Final Basis of Design  
Revised Groundwater Recovery and Treatment System  
Non-Time Critical Removal Action  
Liberty Industrial Finishing Site, Farmingdale, New York

June 25, 2003

### Responses to Comments by the U.S EPA (July 26, 2002) – Enclosure I

### Responses to Comments by the U.S EPA (January 16, 2003) – Enclosure I (EPA's comments)

Figure 4A

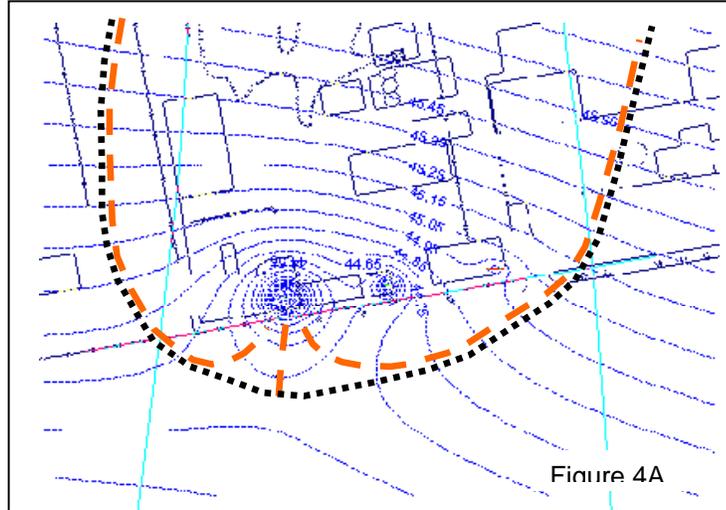
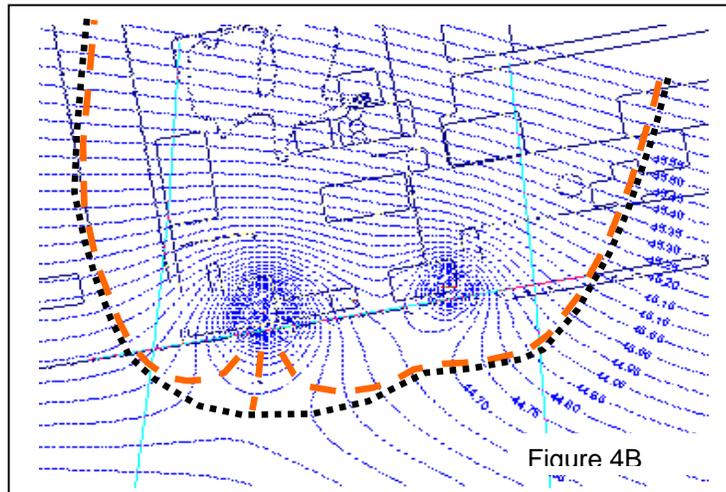
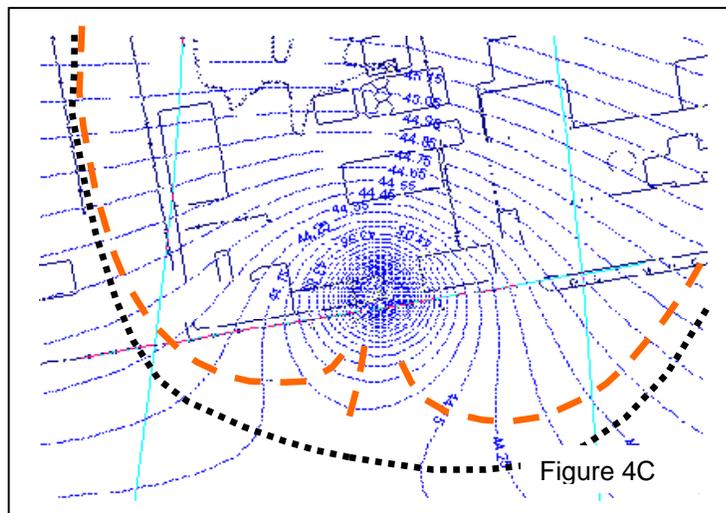
7. *Page 10: The plume limits, as shown on Figure 2, should be superimposed on the figures illustrating the three pumping scenario.*

Response: The light blue lines in Figures 3A through 3B (pumping scenarios) represent the plume limits, as explained in the legend to the figures.

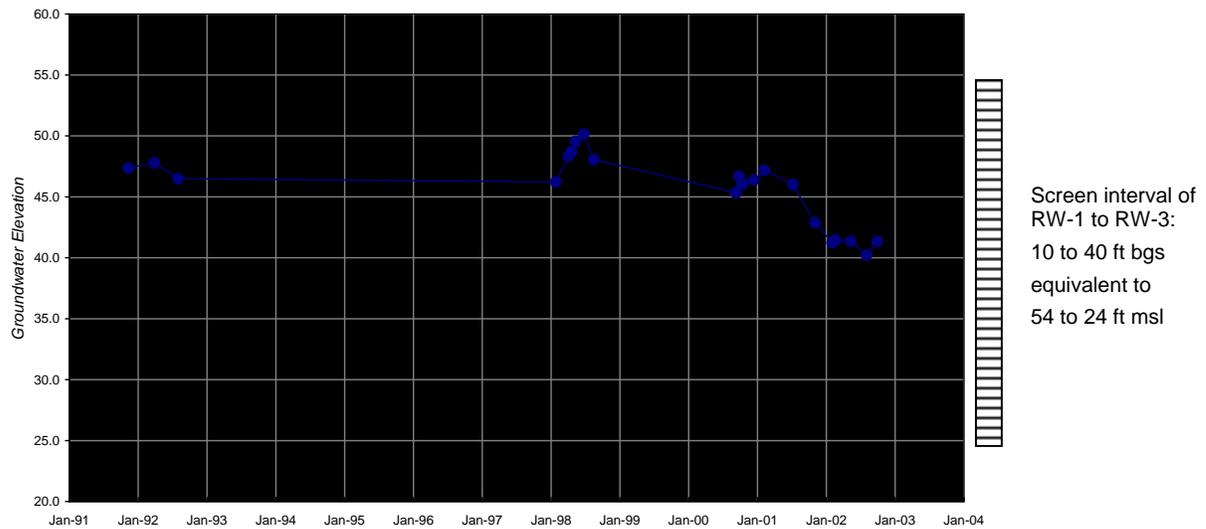
3. Page 1: The report states that as recently as 1999, the groundwater table elevation was 50 ft msl. However, with the recent drought conditions water levels have declined. The report should discuss current and historic water levels, to aid in the selection of a proper screen interval.

Response: The chart below exemplifies the known historic groundwater table fluctuations at the Site, as observed in monitoring well MW-7A. The proposed screen intervals for RW-2 and RW-3 (10 feet to 40 feet below grade) are shown next to the chart. Based on historic observations, there will be at least 15 feet of available drawdown in the recovery wells. Note that the observed drawdown in existing recovery well RW-1 (screen interval is 10 to 40 ft bgs) is less than 4 feet at a pumping rate of 80 gallons per minute.

Figure D-1: Proposed Locations for RW-2 and RW-3

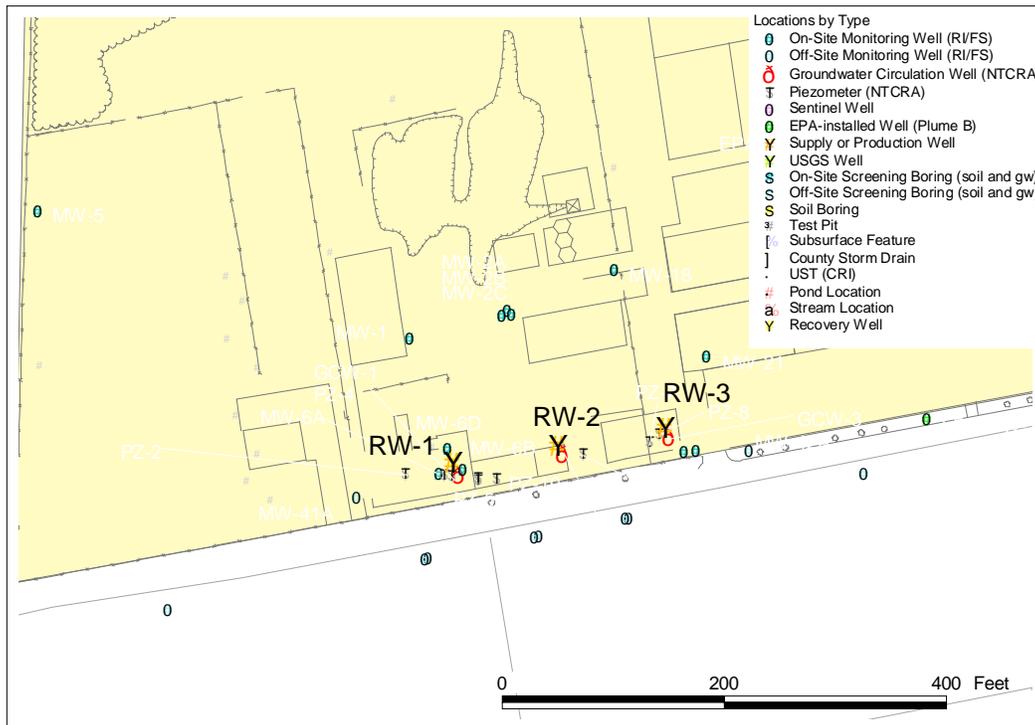
6. *Page 8: The recovery wells should be completed with a pitless adaptor or other approved system to avoid introduction of surface runoff into the well.*

Response: The recovery wells will be completed with a pitless adapter and subsurface connection of the well effluent to the existing piping in the adjacent manhole vaults. Attachment D provides details of the general layout of the surface and subsurface completion of the recovery wells.

Two new recovery wells (RW-2 and RW-3) will be installed at the locations shown in Figure D-1 and according to the specifications shown in Section 3.2 (page 10) of the main document. As shown in Figure D-2, the recovery wells (including the existing well RW-1) will be fitted with a pitless adapter at a depth of about 3.5 feet below grade, connecting with 2-inch diameter PVC pipe to the existing GCW concrete vaults about 8-10 feet to the south. Within the concrete vaults, the new 2-inch PVC lines will be connecting to the existing PVC discharge lines to the treatment building. A separate conduit will supply power from the power hook-up within the existing concrete vault.
